**Albertson Engineering Inc.**

RE: Masonic Lodge Roof Repairs – Phase 1  
Structural Recommendations  
Albertson Engineering File #2021-060

OPTION 3 - STEEL "BAR" JOIST

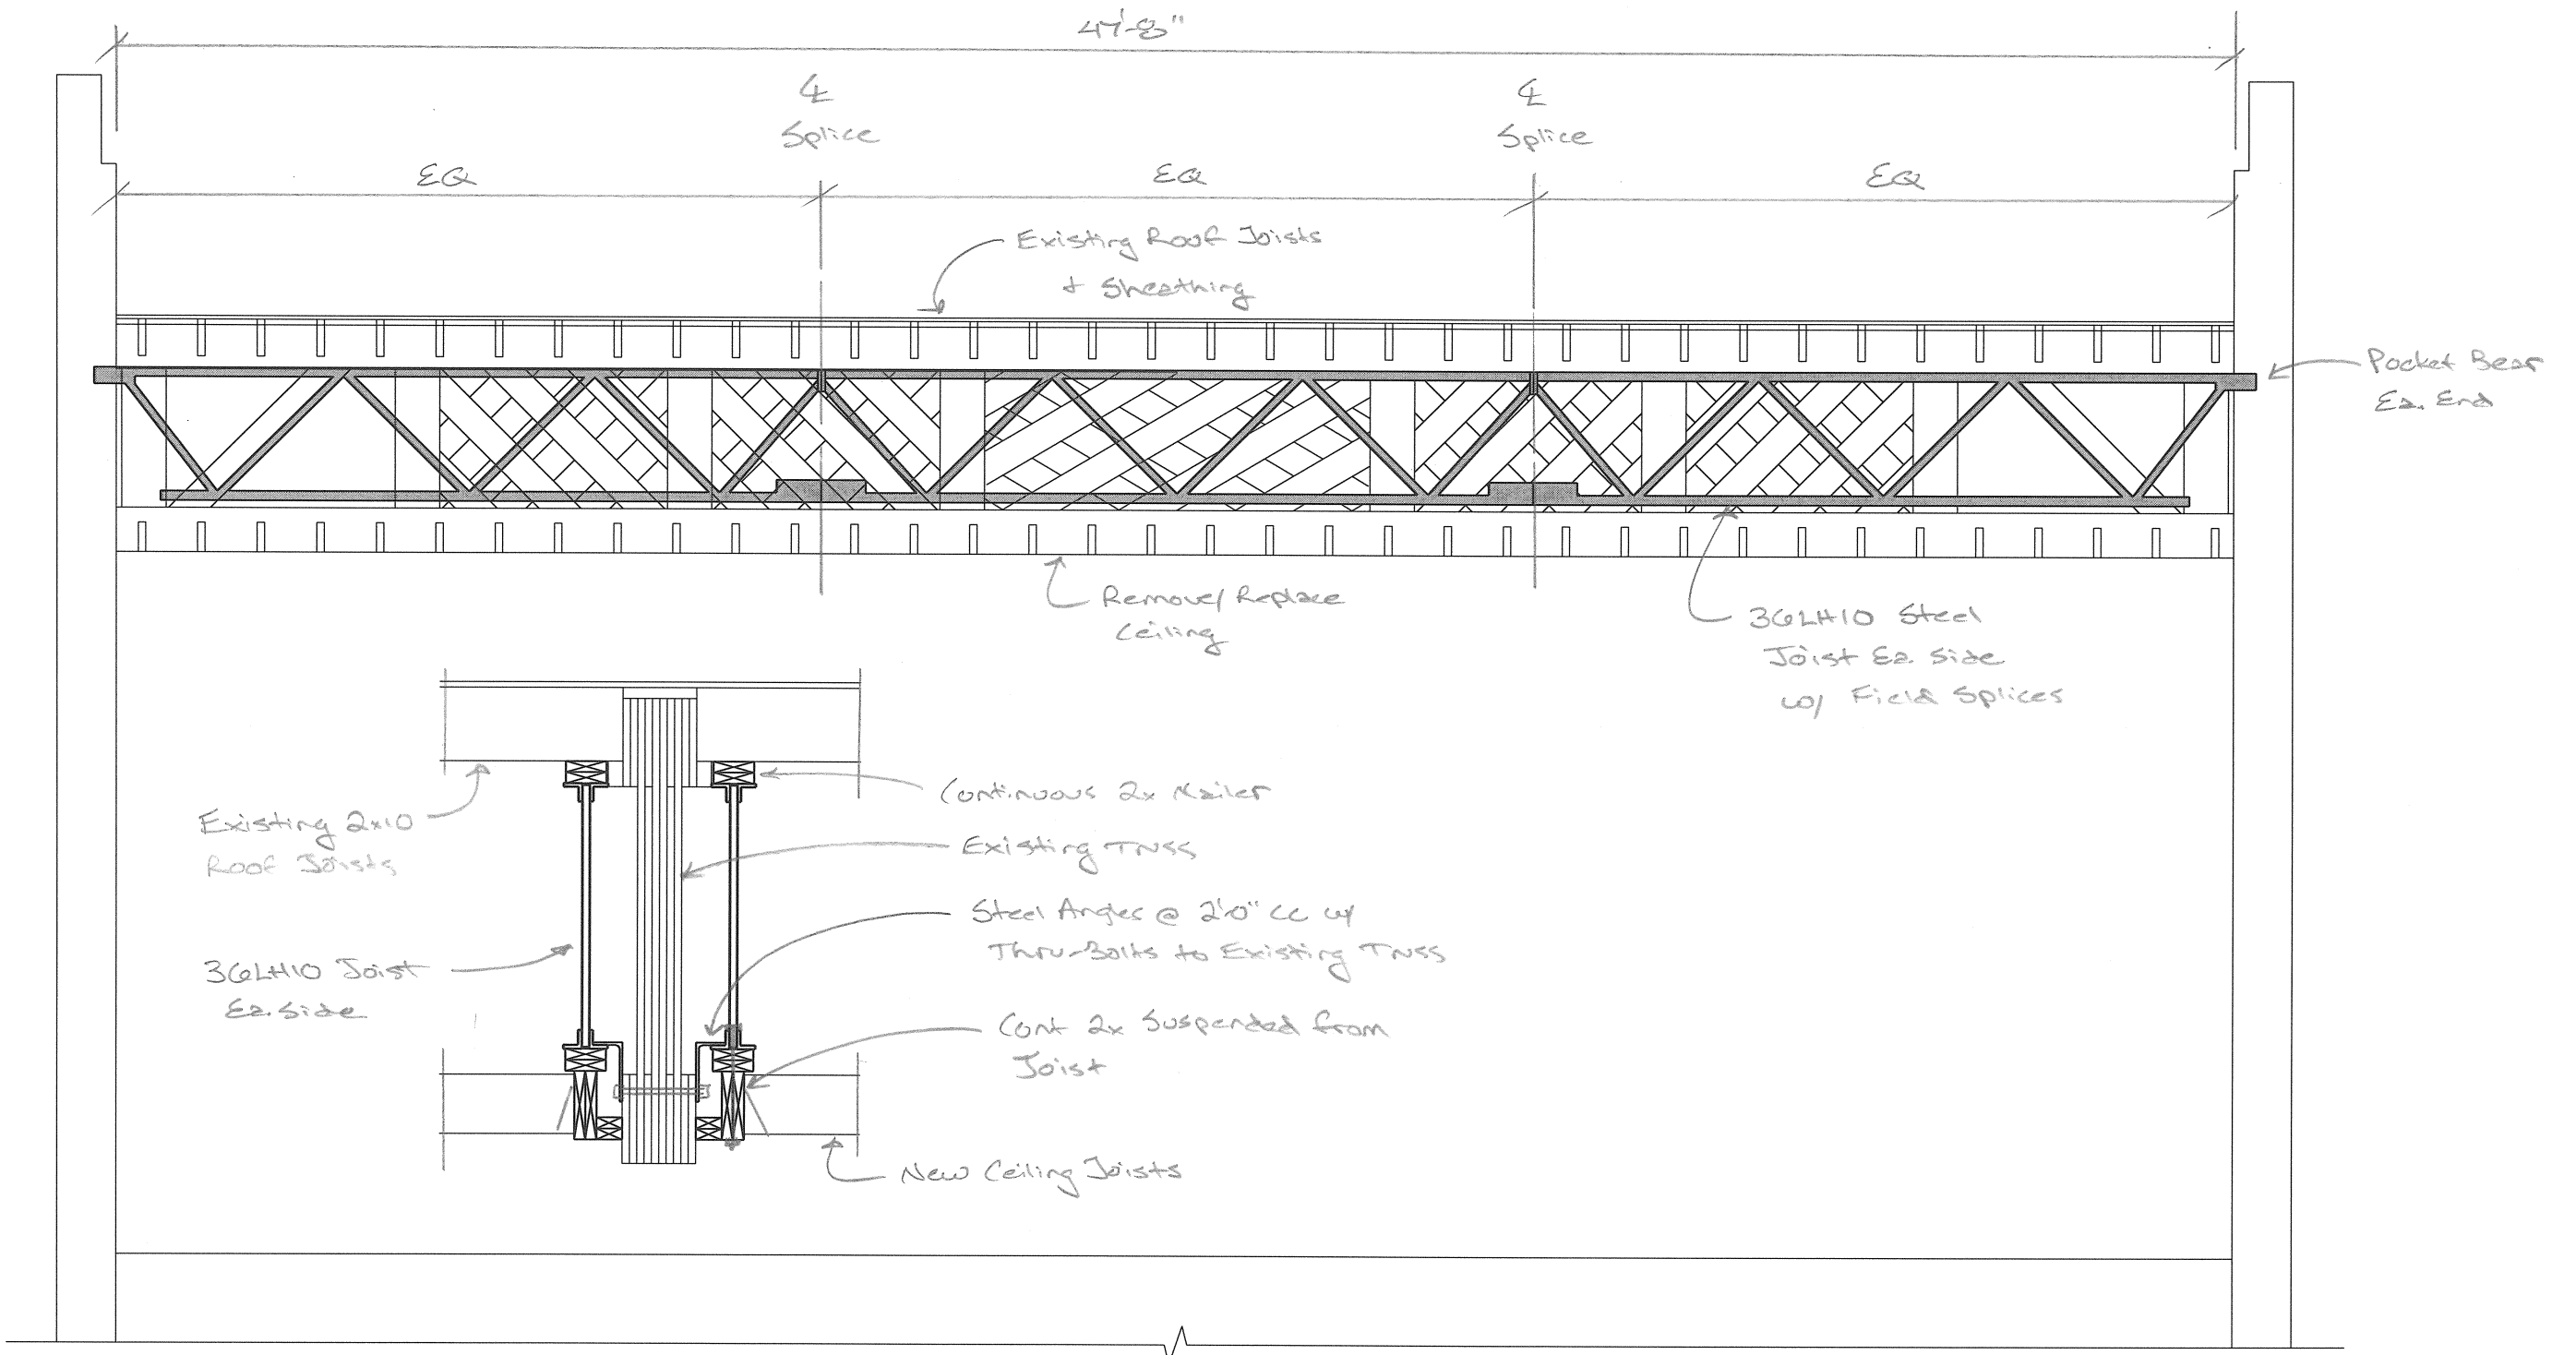
- Option 3 – Steel LH Joists: Provide a new 36LH10 joist on each side of the existing roof truss.
    - LH joists to be field spliced at roughly the third points, with splices designed by the steel joist manufacturer.

- Ceiling framing to either be shored and then suspended from the new steel joists with the use of hangers and continuous 2x blocking, or alternately removed and replaced in its entirety.

- New intermittent bent plate angle hangers and thru-bolts to be provided at the bottom of the joist to engage and carry the existing truss.
    - Joists to be supported each end by cutting out a pocket and bearing the joists directly on the existing brick walls.

OPTION 4 - CUSTOM HSS TRUSS

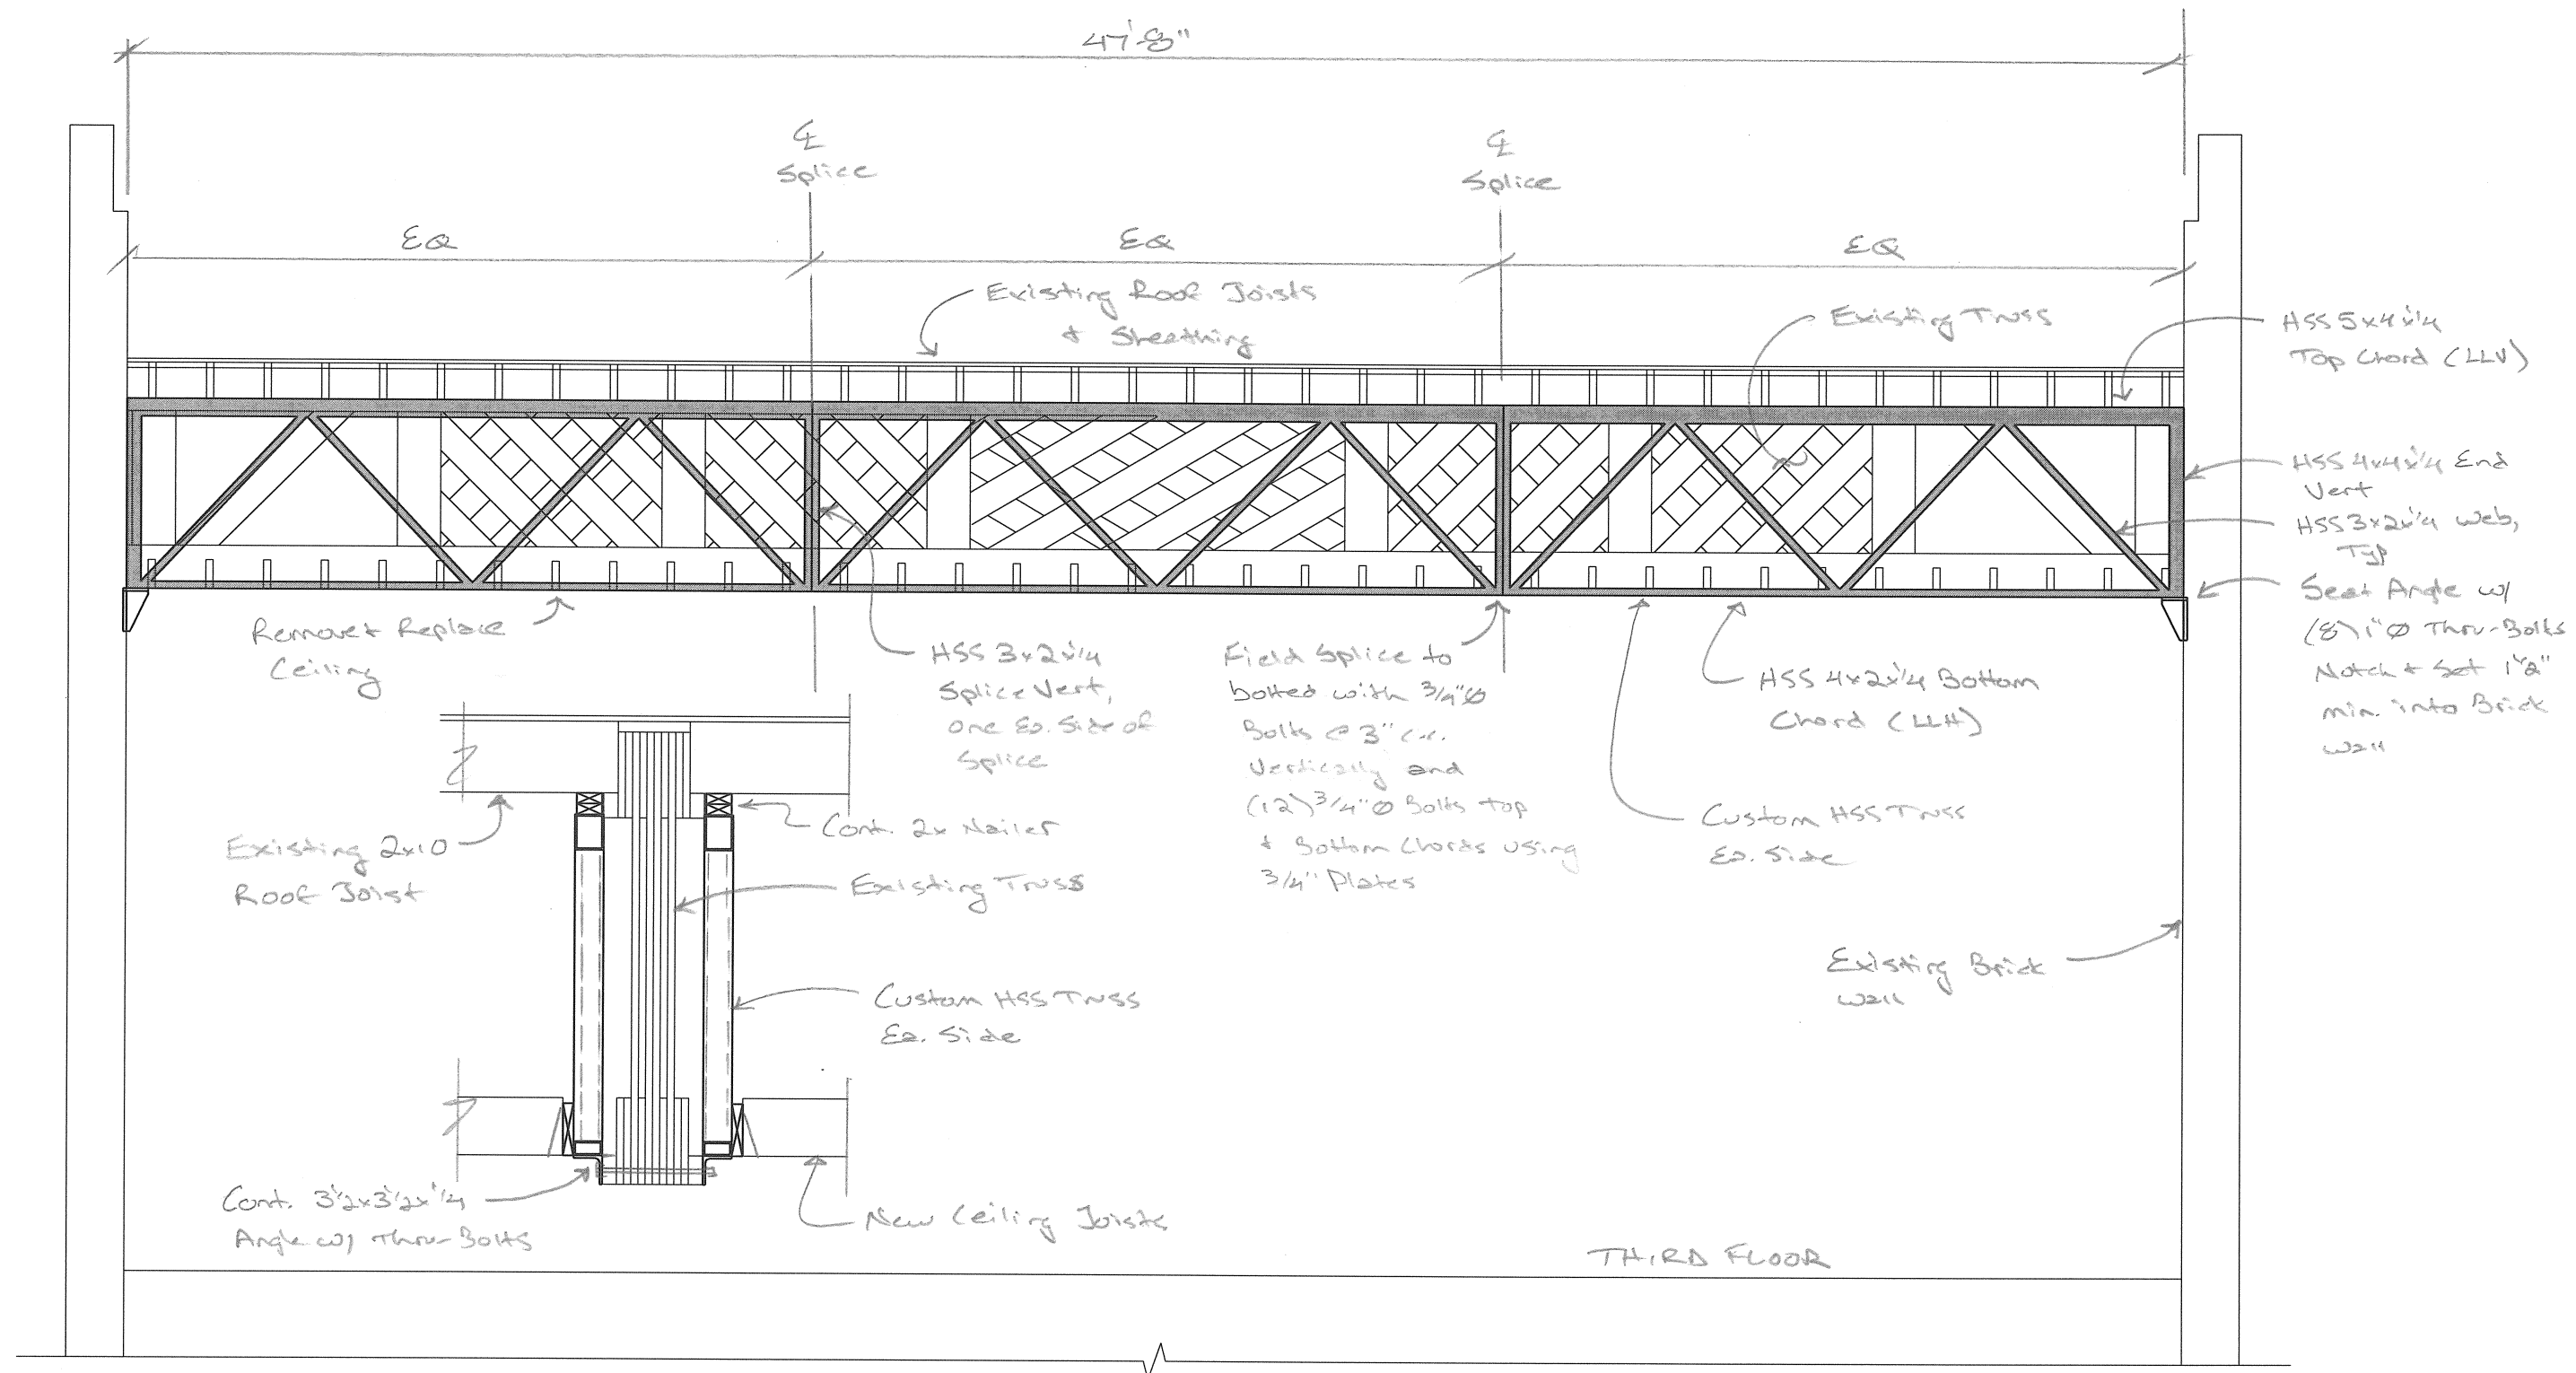
- Option 4 – Custom HSS Truss: Provide a new custom steel tube truss on each side of the existing roof truss.
    - Custom truss to be fabricated from HSS members in three pieces that will then be field spliced with the use of bolted connections. Bolted connections to again use slip critical connections having direct tension indicators or other measures to ensure that pretensioning of bolts has occurred.

- Ceiling framing to either be shored and then suspended from the new custom truss with the use of hangers and continuous 2x blocking, or alternately removed and replaced in its entirety.

- A continuous angle and thru-bolts will be provided at the bottom to engage and carry the existing truss.
- HSS truss to be supported each end with a seat angle assembly similar to that described for the steel beam option.
